YAMAHA MOTOR CORPORATION, U.S.A.

00V-281

CY50N

FACTORY MODIFICATION CAMPAIGN

AFFECTED RANGE

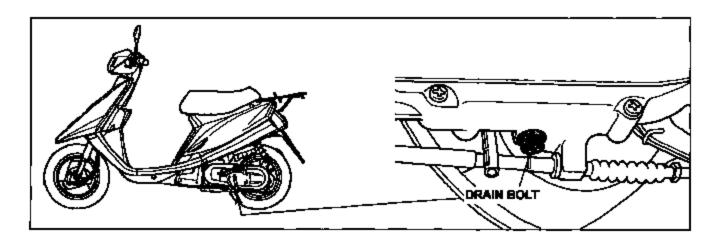
4FB-052689 ~ 052988
